Development Review Committee (DRC) Meeting

Tuesday, November 7th, 2023 – 9:30 AM

Subject Case # 23-03-MAJPUD-Tailwinds Commercial

The applicant is requesting review of a major PUD amendment to the Swallows Golf and Country Club (Glen Abbey) PUD, located on the southeast corner of U.S. Highway 17/92 and North Pine Meadow Drive. The proposed amendment amends the permitted uses for the subject property to include a drive-through oil change, a restaurant, and a self-storage facility, and provides for development standards.

CONCEPTUAL SKETCH "Y"

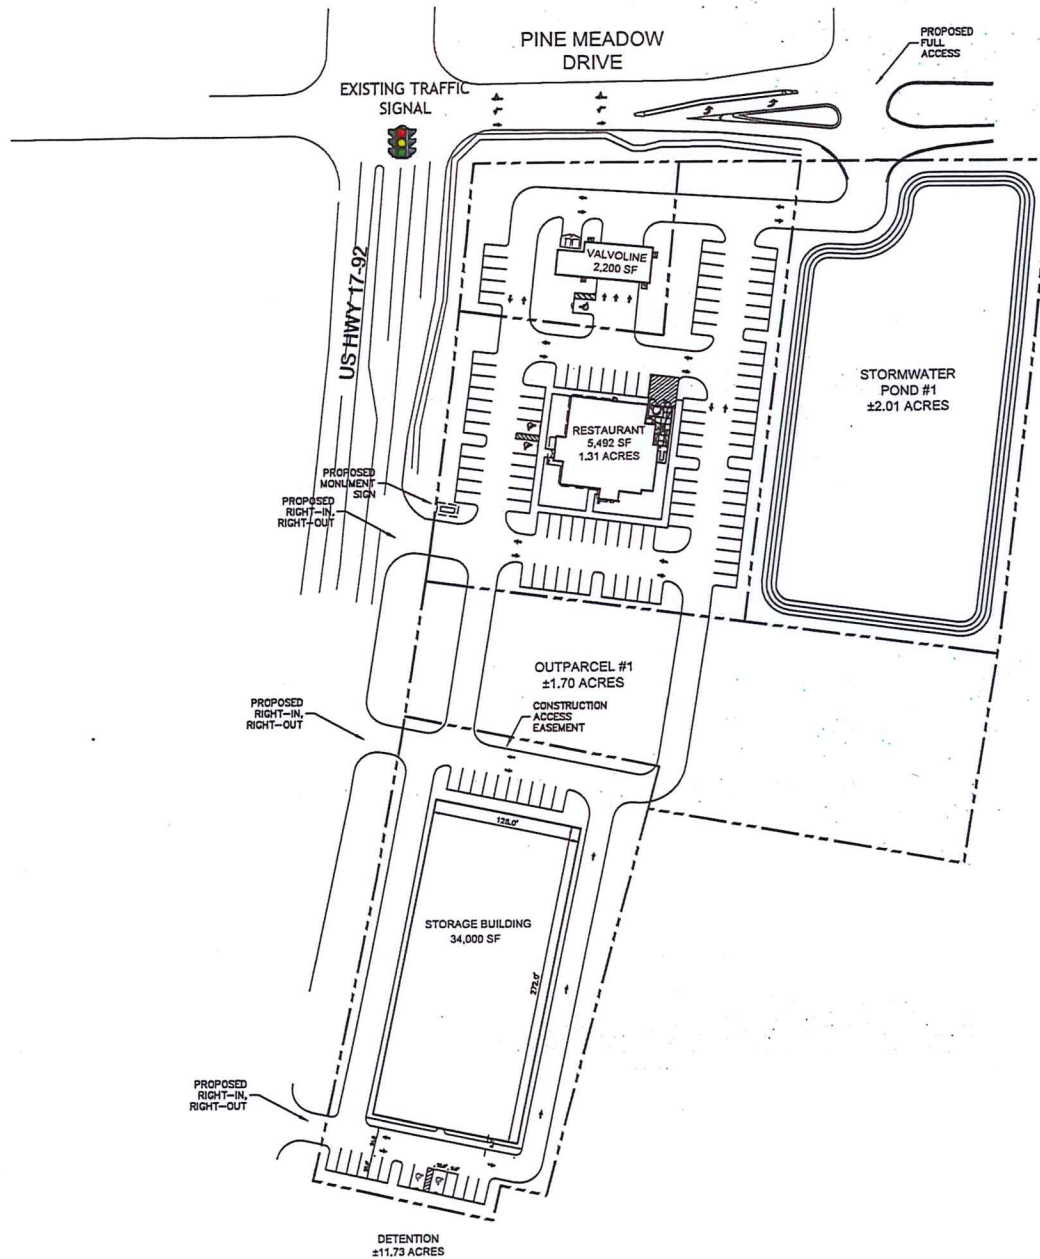
services. **There is an outparcel between the storage building and the restaurant. What is the intended use for this outparcel?**

Policy 5.403(b)(3) states areas in this land use classification will be well designed from the perspective of pedestrians and bicyclists. **The Valvoline may conflict with this policy, due to its auto-centric nature, as it abuts the corner of the intersection and the meandering trail along North Pine Meadow Drive. A use more beneficial to pedestrians would better meet the requirements of this policy.**

Section 3-129(8) provides for minimum off-street loading spaces. Restaurants and commercial storage facilities both require off-street loading spaces. **Please delineate the location of these loading spaces on the conceptual plan.**

Section 3-129(1) provides for required bicycle parking. Restaurants are required to provide parking spaces for bicycles. **Please delineate the location of these spaces on the conceptual plan.**

Section 5-4(2), Table I provides for minimum buffer yards and screening. Commercial uses adjacent to single-family residential use/zoning must have a buffer width of 30 feet, with the screening being masonry wall and landscaping. **The design shown in the conceptual plan would fail to meet this requirement.**

Section 5-124 provides for a minimum 20-foot landscape buffer along the Gateway Corridor. **It would appear parts of the project's frontage fails to meet this requirement, including the storage building.**

1. Per the proposed Concept Plan by Kimley Horn, this project may impact jurisdictional wetlands and will require an Environmental Resource Permit from the St. John's River Water Management District. If wetlands are impacted, a 404 Permit from the Florida Department of Environmental Protection and a wetland alteration permit from the City of DeBary may be required. Please provide a Biological Report that addresses these issues.
